PHASE 1 SCHEMATIC DESIGN

NSW DEPARTMENT OF
EDUCATION

NORTH SYDNEY PUBLIC
SCHOOL

SEC. 4.55 MODIFICATION ITEMS

1 PLAN
BUILDING J - LEVEL 1 FLOOR PLAN
SCALE: 1:100

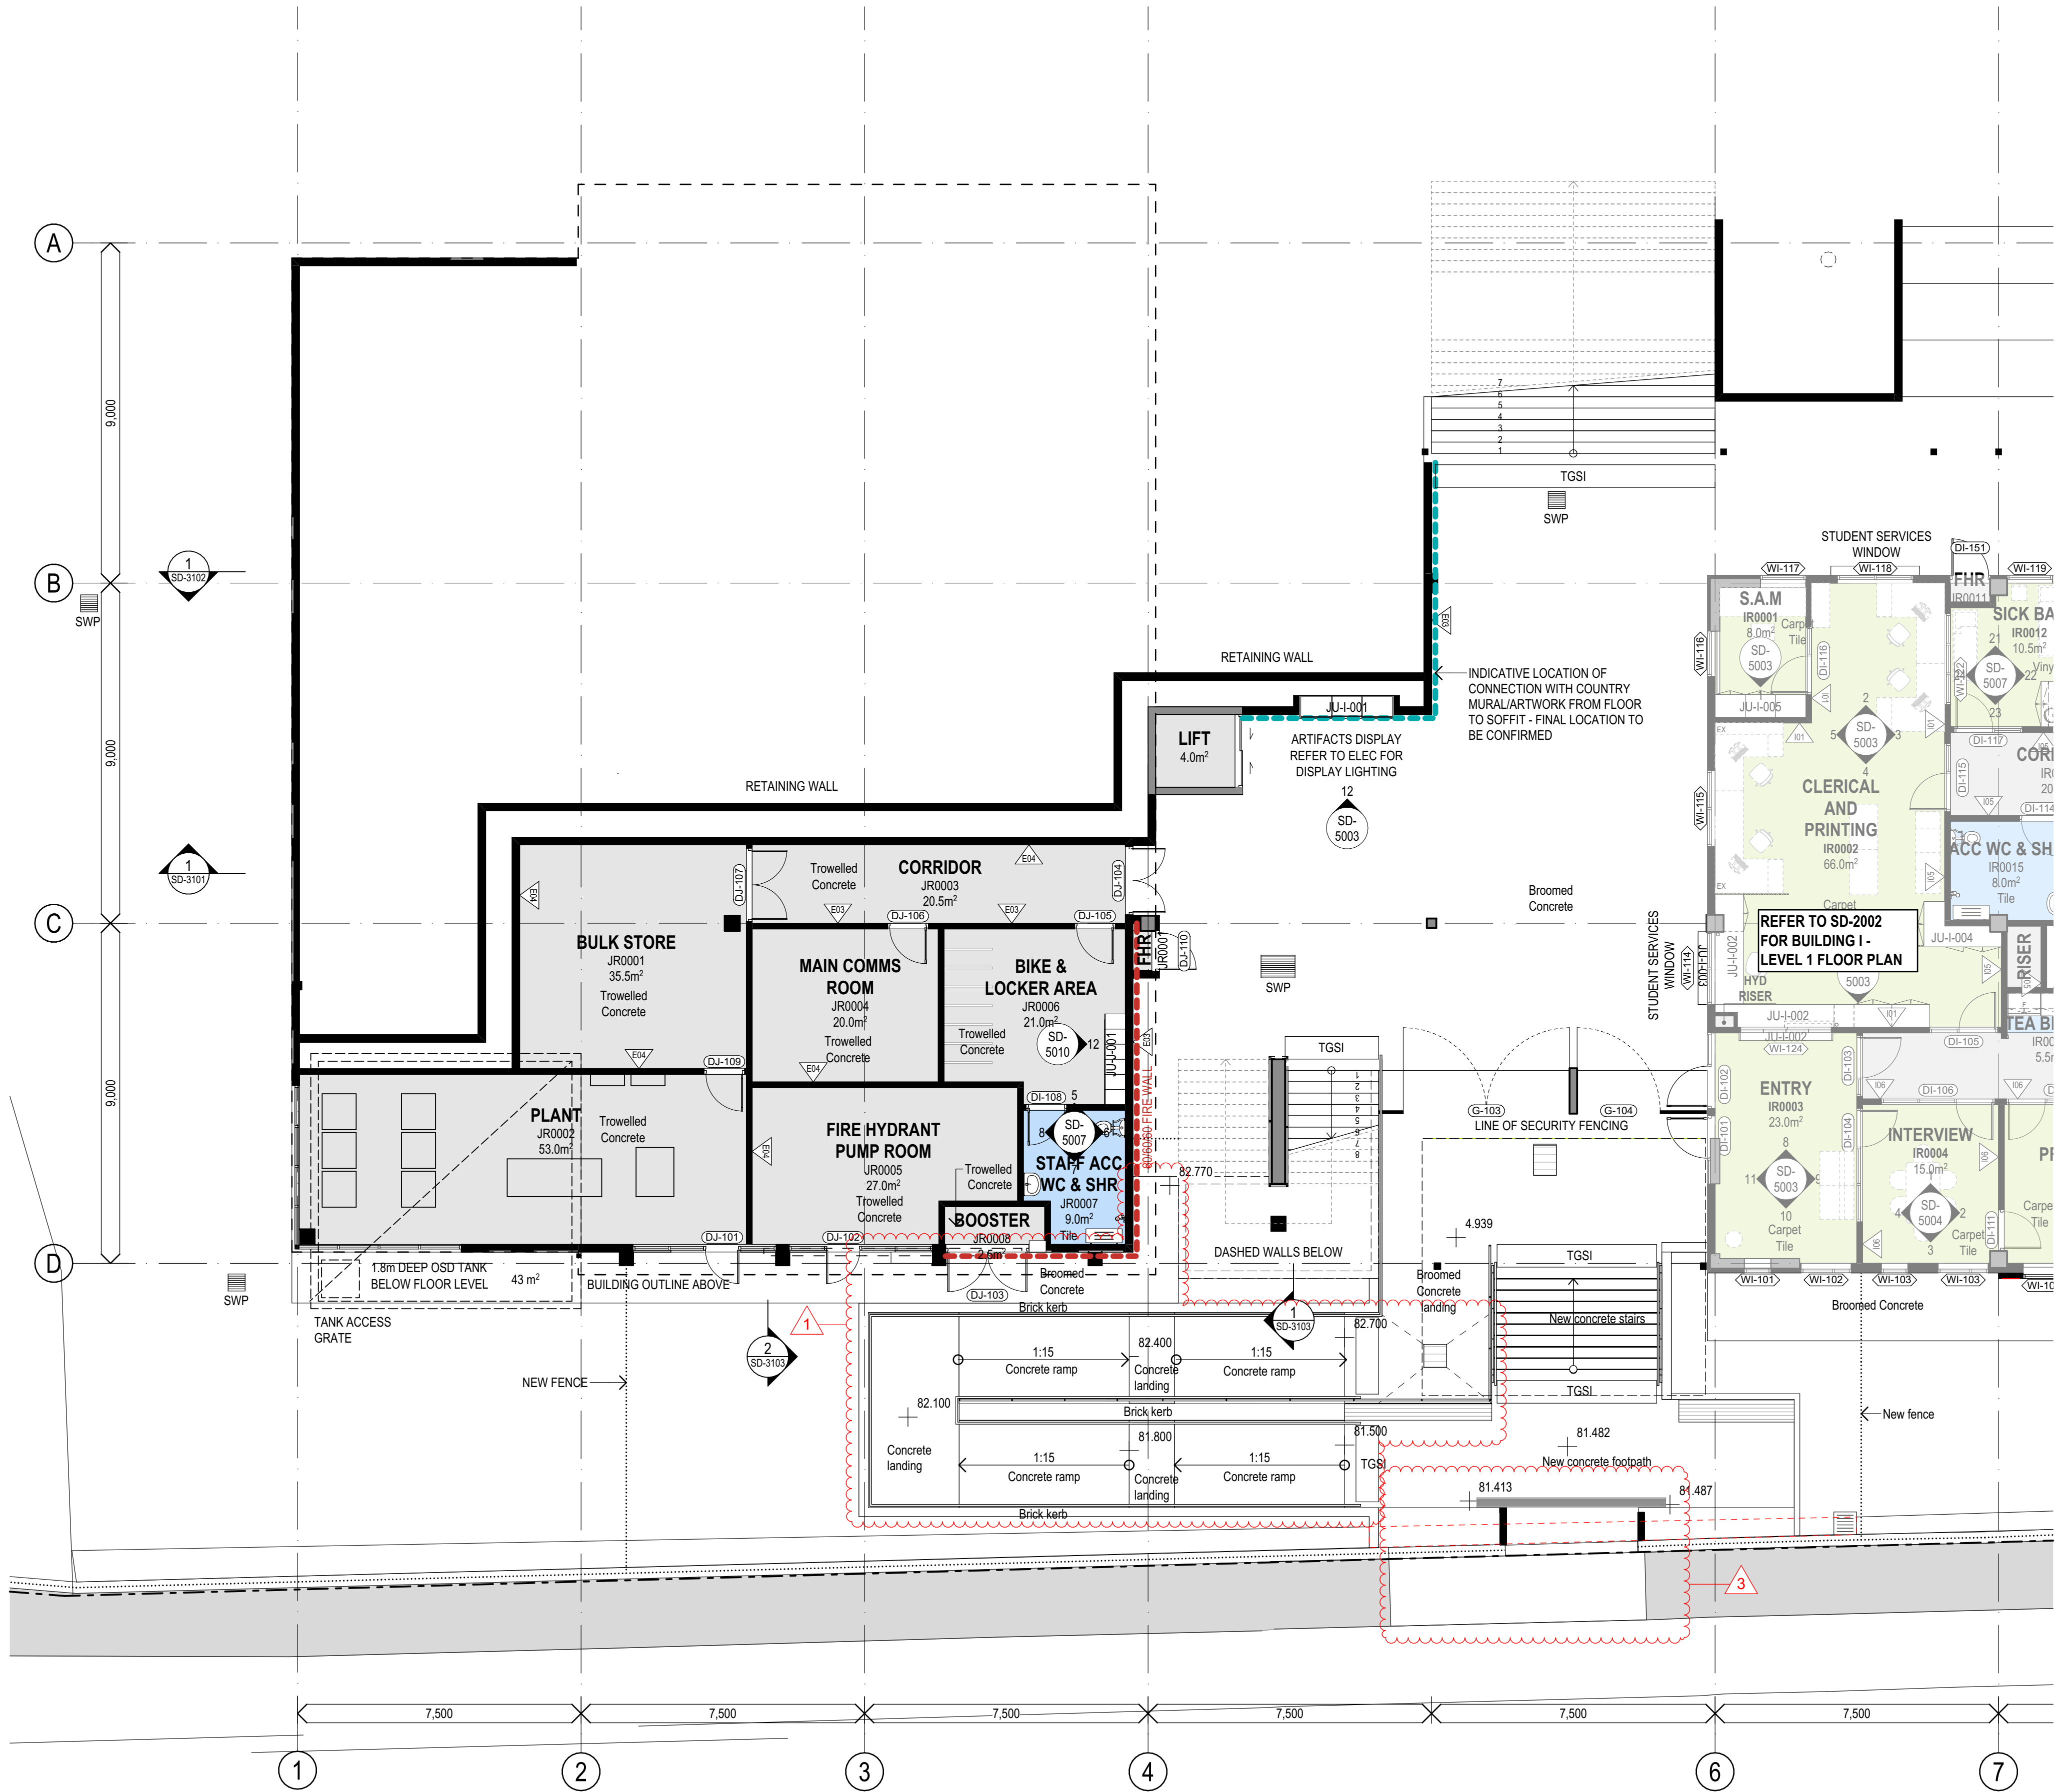
- ENTRY RAMP RECONFIGURATION TO BE 1:15, ADDITIONAL SLAB TO ACCESS PLANT ROOM
- HERITAGE FENCE TEMPORARY REMOVAL
- ADDITIONAL CLEANER'S CUPBOARD
- LIBRARY ENTRY DOOR MOVED DUE TO CLEANER STORE BEING ADDED, NOW ALIGNS WITH LIFT
- WALL ALIGNMENT OF WC'S LEVEL 3
- WINDOW CHANGES TO BUILDING I SOUTH & EAST ELEVATIONS ON L1 / L2 / L3. WINDOWS INCREASED IN SIZE FOR COMPLIANCE WITH BCA PART F4 - LIGHT AND VENTILATION. FIXED GLAZED PANEL INTRODUCED TO LOWER SECTION OF L2 / L3 WINDOWS TO MEET MIN 1200MM SILL HEIGHT REQUIREMENT IN EFSG. LARGER OPENABLE AWNINGS INTRODUCED FOR NATURAL VENTILATION COMPLIANCE.
- LOUVERED DOORS CHANGE FROM SINGLE TO DOUBLE DOOR TO SUIT PLANT ROOM REQUIREMENTS.

1 PLAN
BUILDING I - LEVEL 2 FLOOR PLAN
SCALE: 1:100

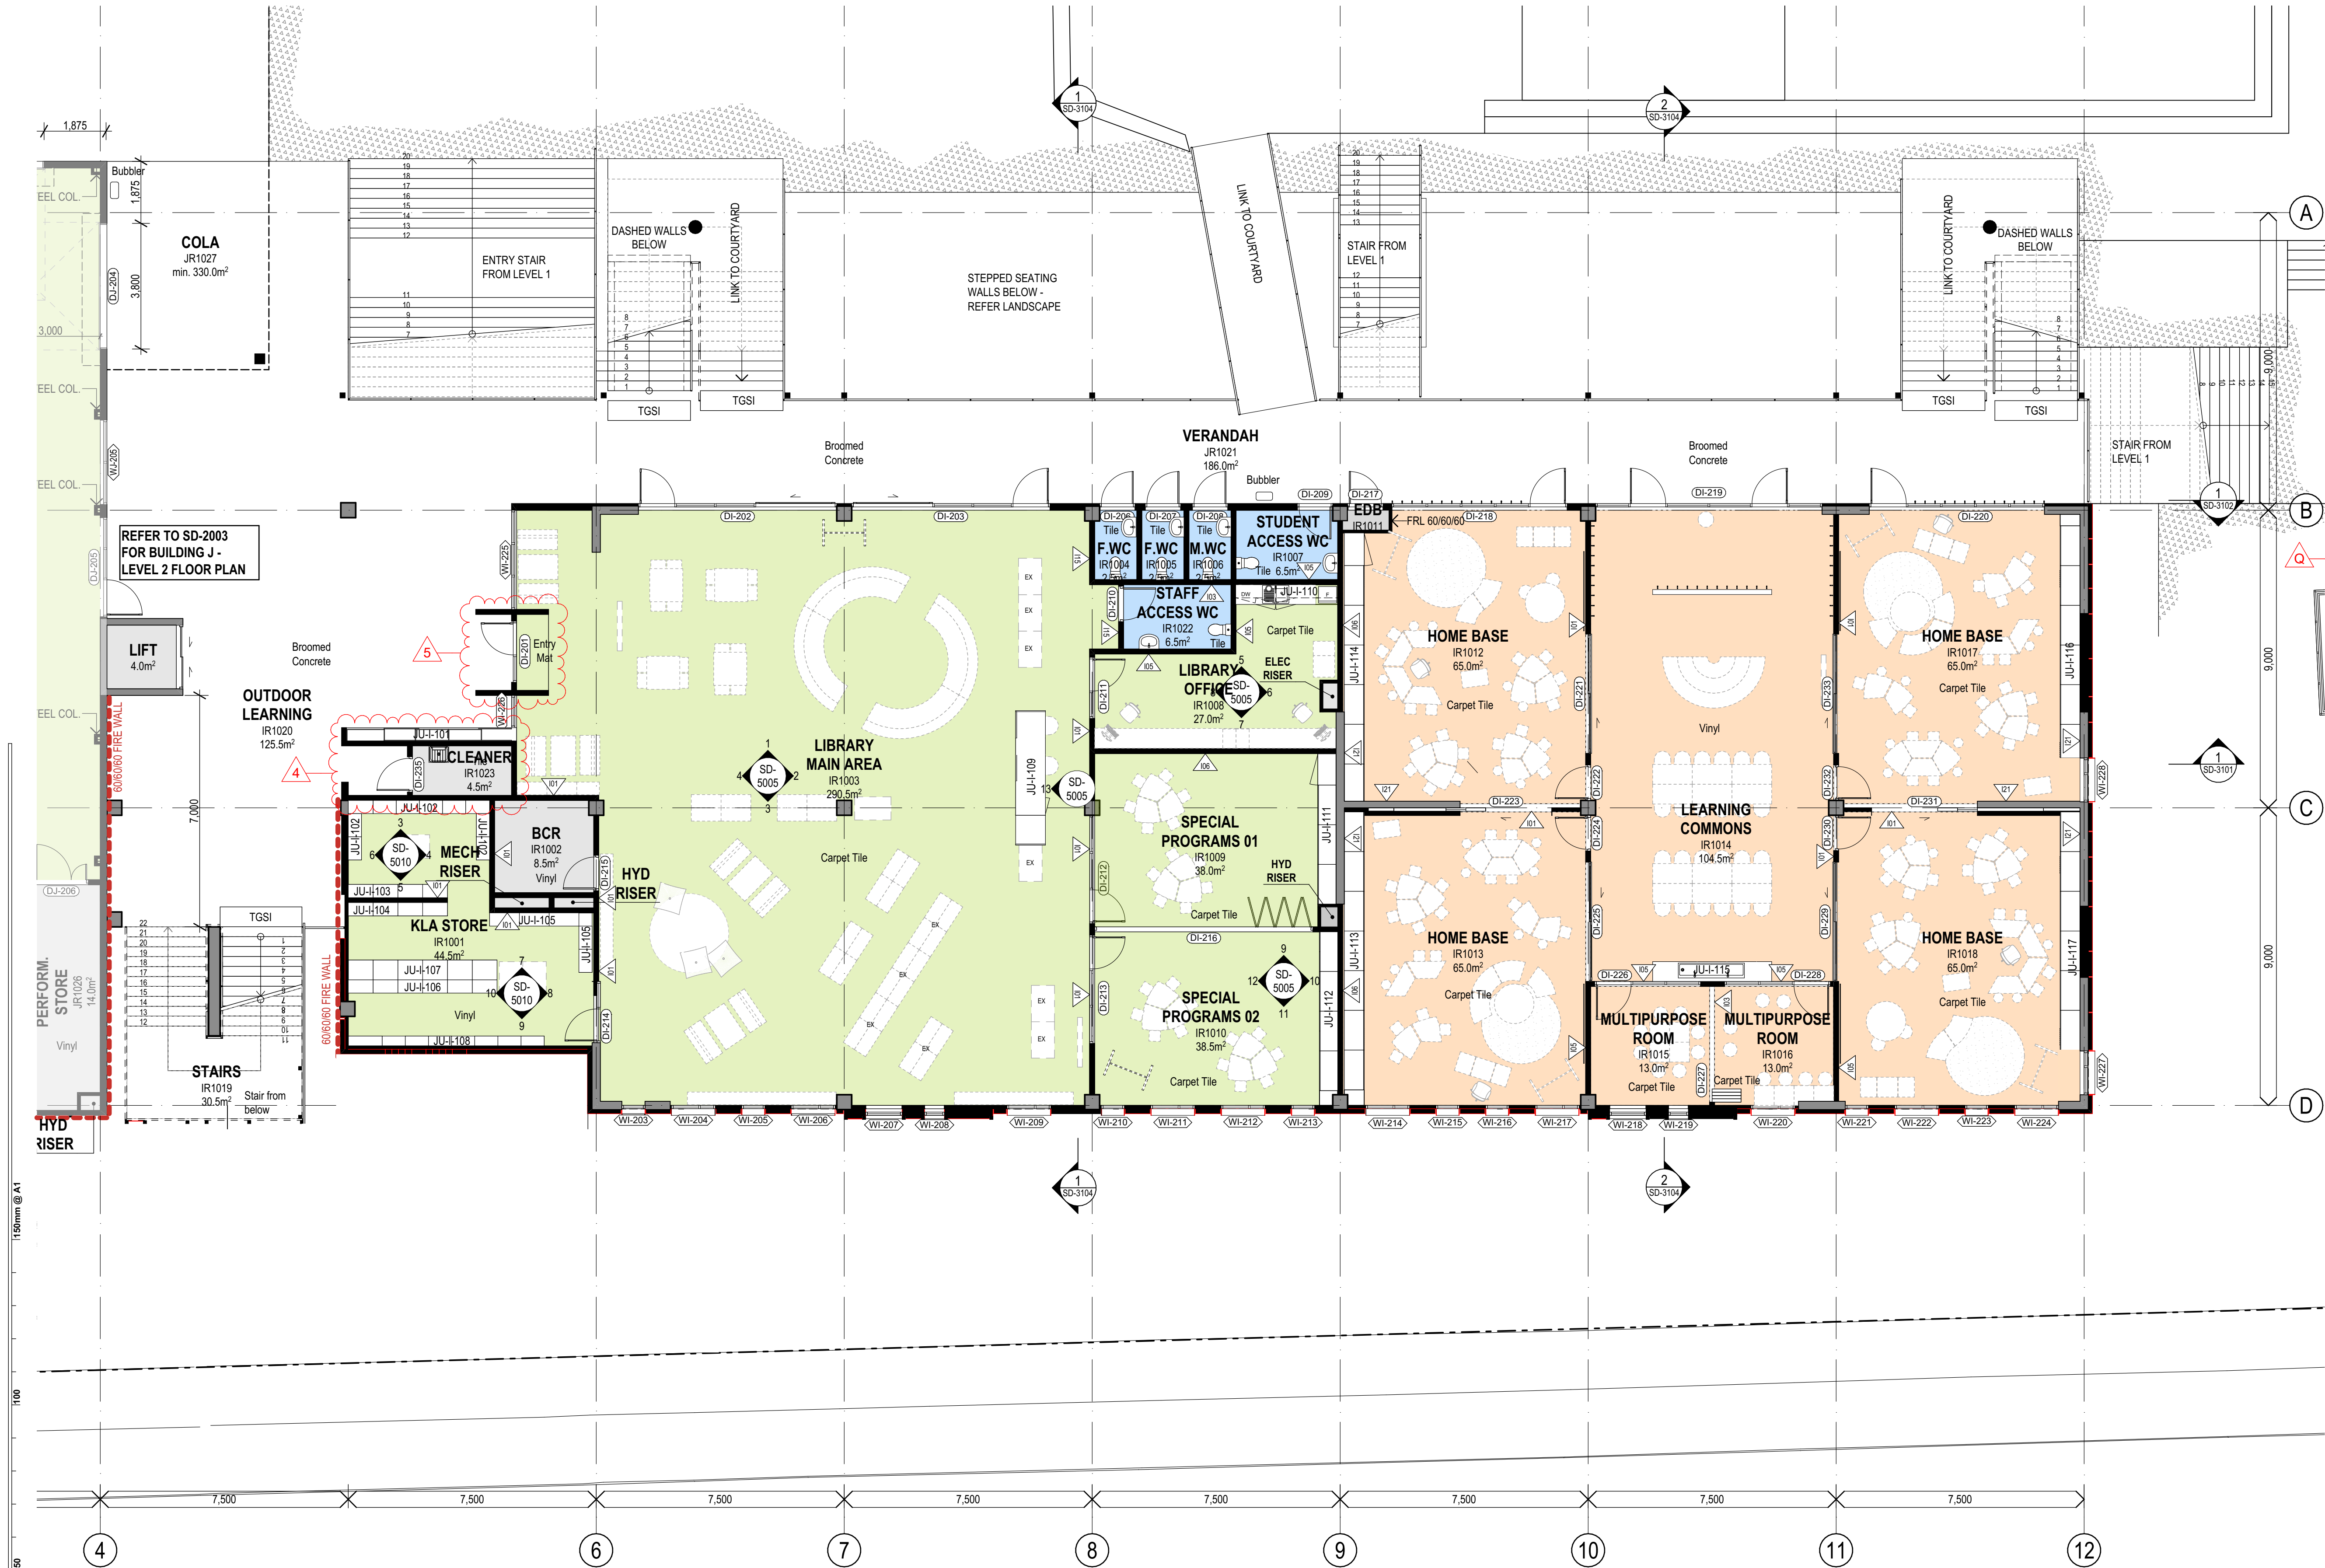
- ENTRY RAMP RECONFIGURATION TO BE 1:15, ADDITIONAL SLAB TO ACCESS PLANT ROOM
- HYDRANT BOOSTER LOCATION
- HERITAGE FENCE TEMPORARY REMOVAL
- ADDITIONAL CLEANER'S CUPBOARD
- LIBRARY ENTRY DOOR MOVED DUE TO CLEANER STORE BEING ADDED, NOW ALIGNS WITH LIFT
- WALL ALIGNMENT OF WC'S LEVEL 3
- WINDOW CHANGES TO BUILDING J SOUTH & EAST ELEVATIONS ON L1 / L2 / L3. WINDOWS INCREASED IN SIZE FOR COMPLIANCE WITH BCA PART F4 - LIGHT AND VENTILATION: FIXED GLAZED PANEL INTRODUCED TO LOWER SECTION OF L2 / L3 WINDOWS TO MEET MIN 1200MM SILL HEIGHT REQUIREMENT IN EFSG. LARGER OPENABLE AWNINGS INTRODUCED FOR NATURAL VENTILATION COMPLIANCE.
- LOUVERED DOORS CHANGE FROM SINGLE TO DOUBLE DOOR TO SUIT PLANT ROOM REQUIREMENTS.
